MEMORANDUM

To	Kate Berg (City of Melbourne)	From	Julian Skipworth
Copy	Luke Cunningham and Rianda Mills (Rain Consulting)	Reference	30005 CityOfMelb Southbank TUFLOW Modelling
Date	21 April 2020	Pages	9
Subject	Southbank Flood Modelling Update and Climate Change Scenarios

Figure 3 Limit of Mapping

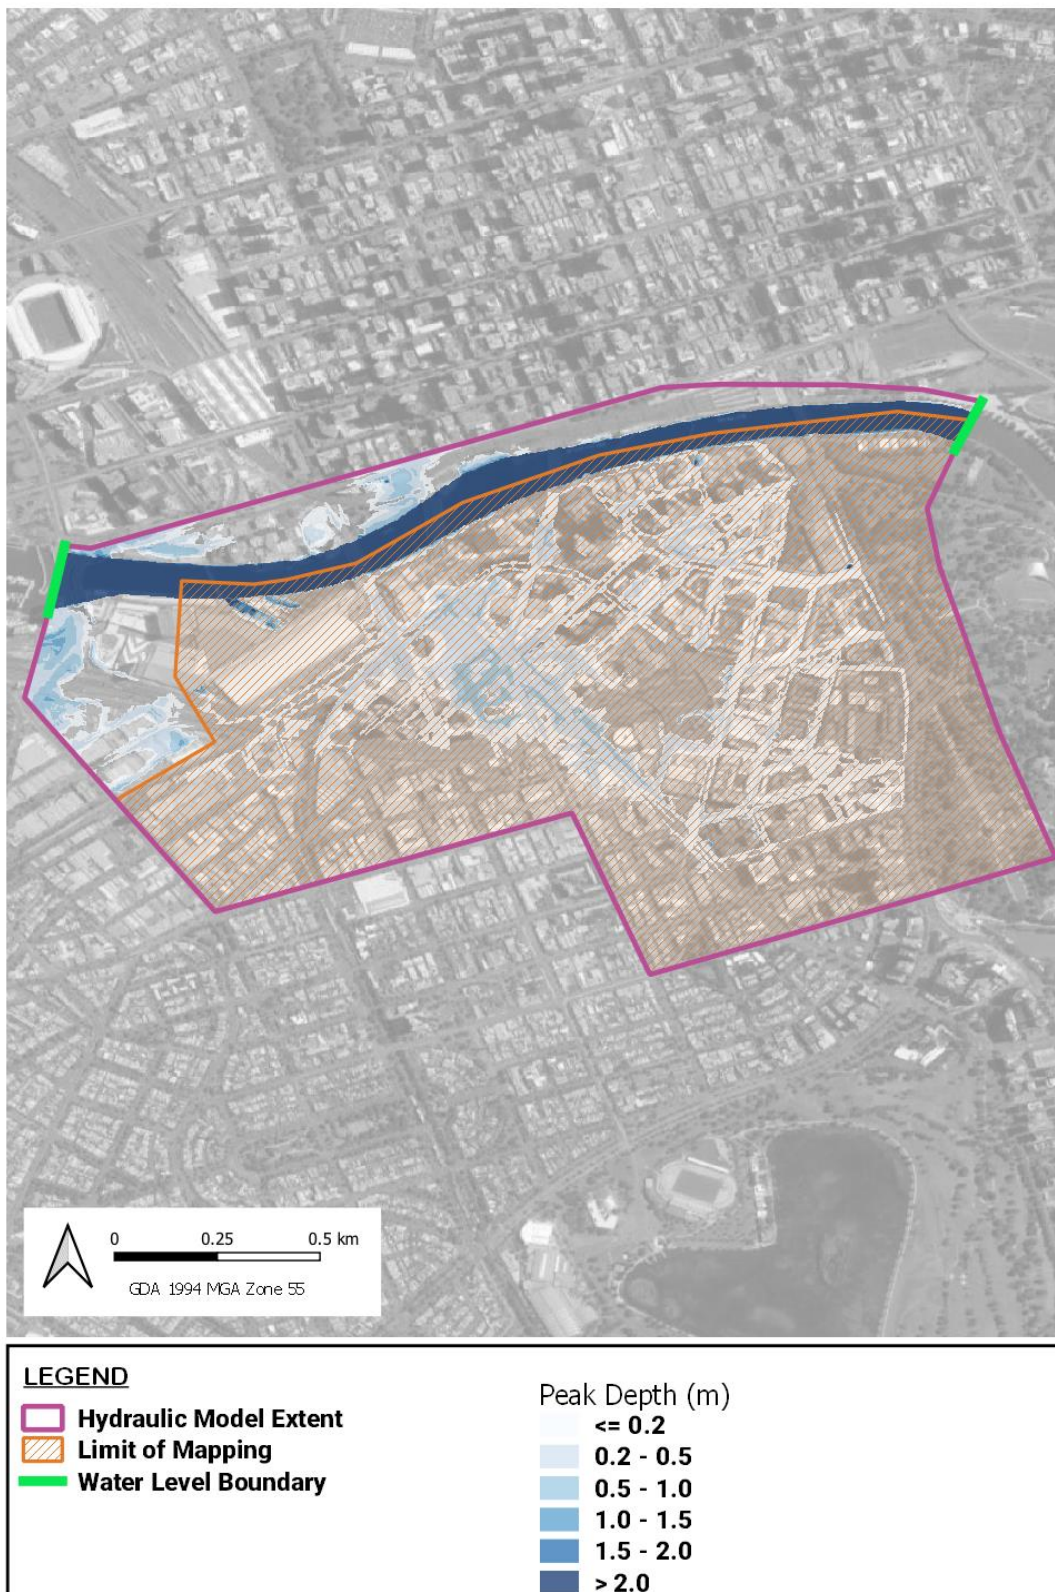
with the assumption that nearly all buildings will be directly connected to the Council and road drainage network.	
Limits of Mapping	It is recommended that when the results are processed and combined with other datasets that they are clipped back to the polygon shown in Figure 3. This polygon is the recommended limit of mapping and ensures any erroneous results in close vicinity to the downstream boundary are removed from the dataset.	It is recommended that the results are clipped to the Limit of Mapping polygon shown in Figure 3 (also provided as a Shapefile).
